CERTIFICATE OF APPROPRIATENESS

ITEM A07
HPO File #: HP2026_0240

3963 Del Monte Dr.
Landmark: Baldwin-Riddell House

Proposal: New Construction – Pool House

WINDOW SCHEDULE

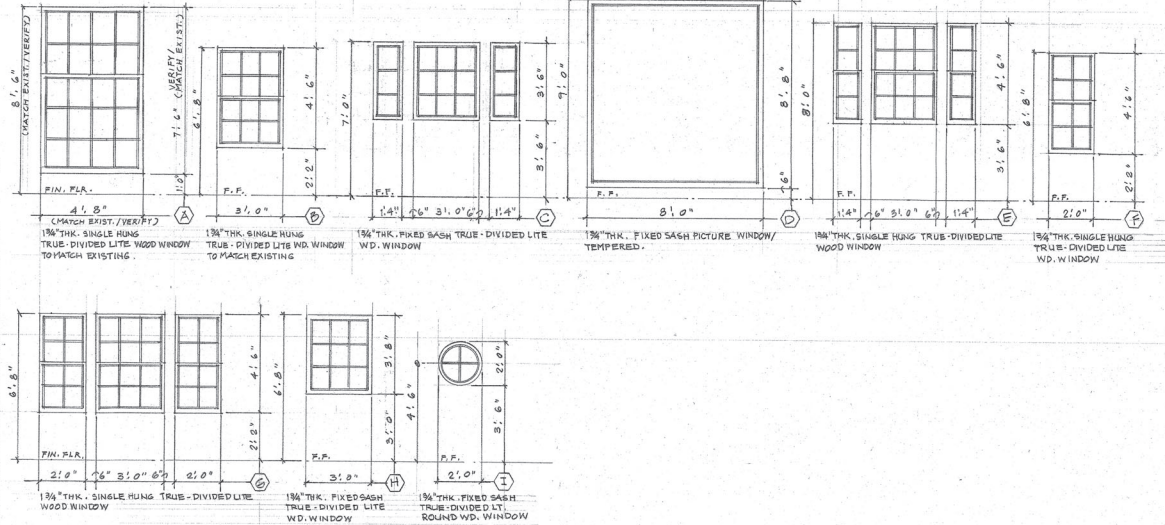
SEE WINDOW AND DOOR SCHEDULE GARAGE ELEVATION SHEET A4.0

ALL NEW WINDOWS MUST BE INSET 1¼ Inches – See Attachment

1-over-1 Windows Must Be Equally Horizontally Divided

Historic Window Standard: New Construction & Replacement

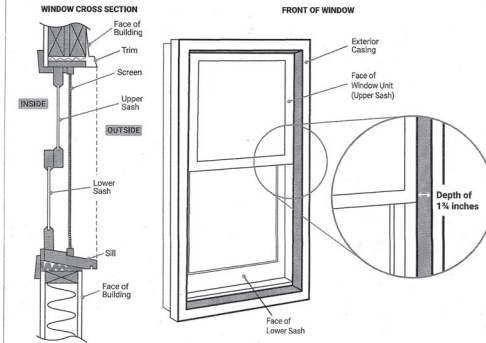
Minimum 1 1/4 inch Inset

- Depth from Exterior Casing to the Face of the Window Unit (Upper Sash)
- Windows must be 1-over-1 (equally horizontally divided)
- 1 1/4 inch minimum inset for Fixed Window
